Addendum No. 5
 MUN-09 Feeder Cable Replacement & Pad Mount Switchgear
 TFM-048-25/TU-509-23

Addendum No. 4
 MUN-09 Feeder Cable Replacement & Pad Mount Switchgear
 TU-509-23

MUN-09 FEEDER CABLE REPLACEMENT
& PAD MOUNT SWITCHGEAR
(TU-509-23)

Drawing No. E101
Revision

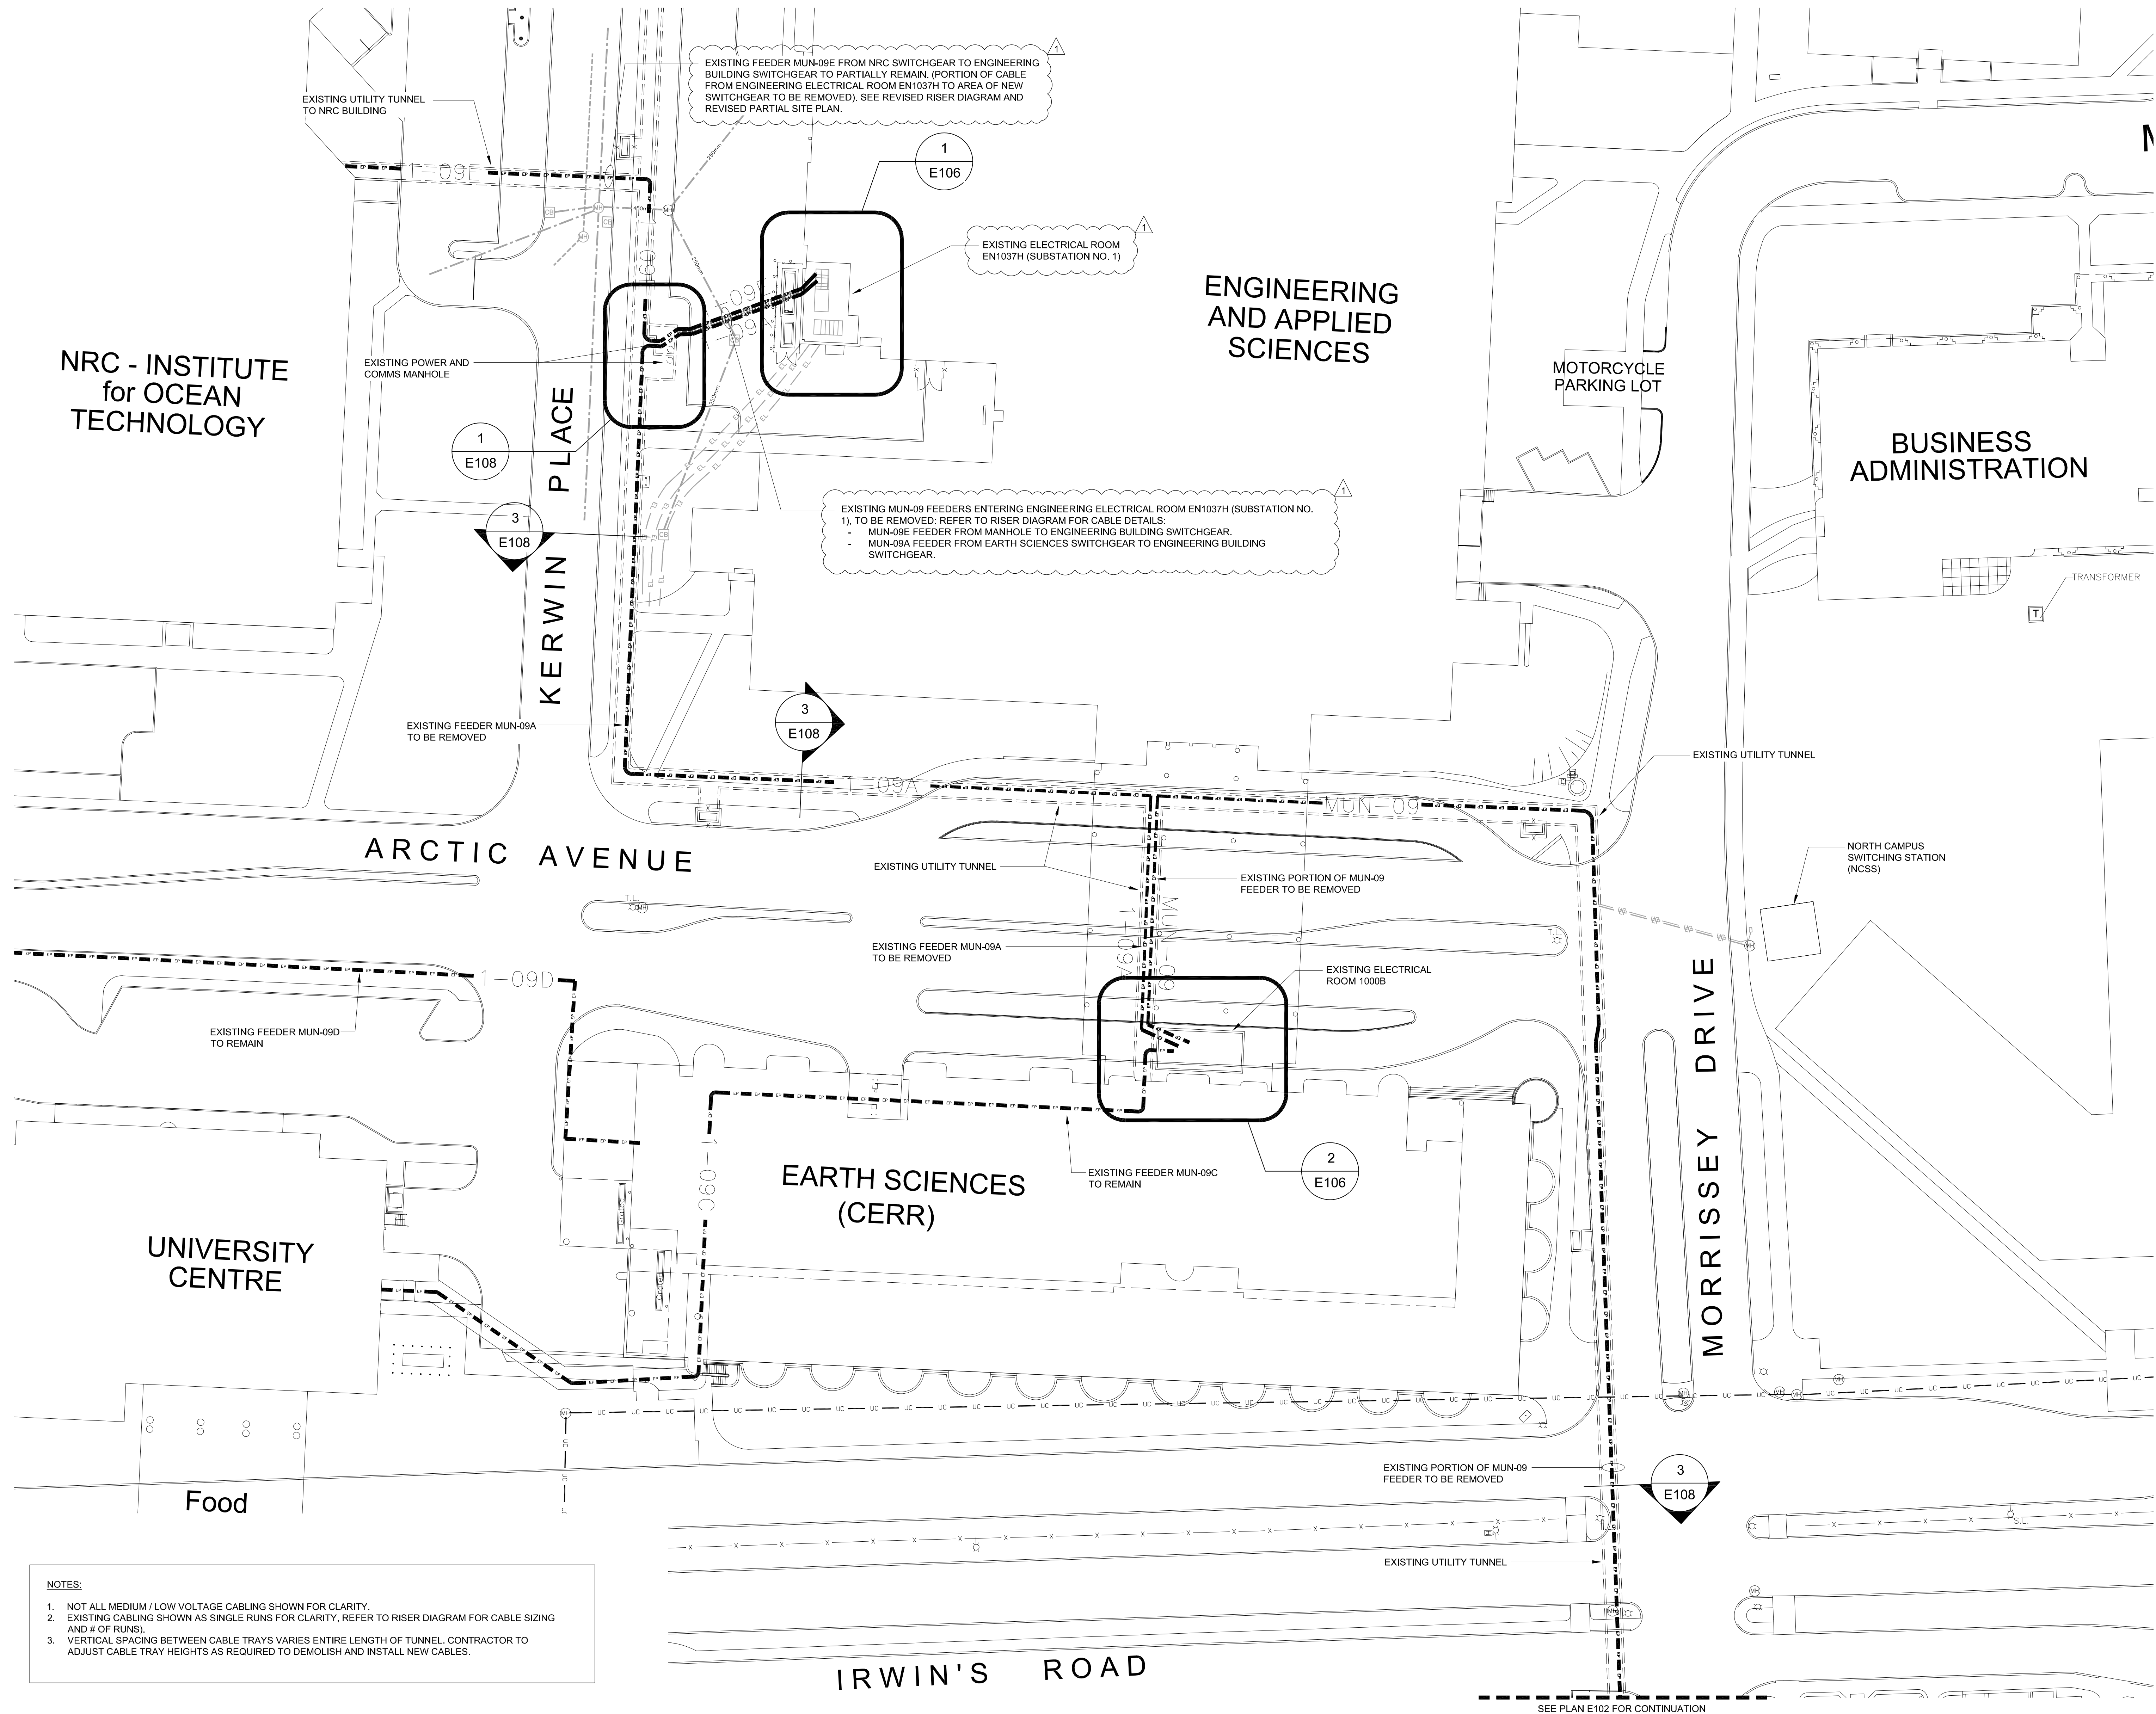
- .1 Reference Drawing E101 – Partial site plan, Demolition North - Revised
- .2 Reference Drawing E107 – Partial floor plan - Revised
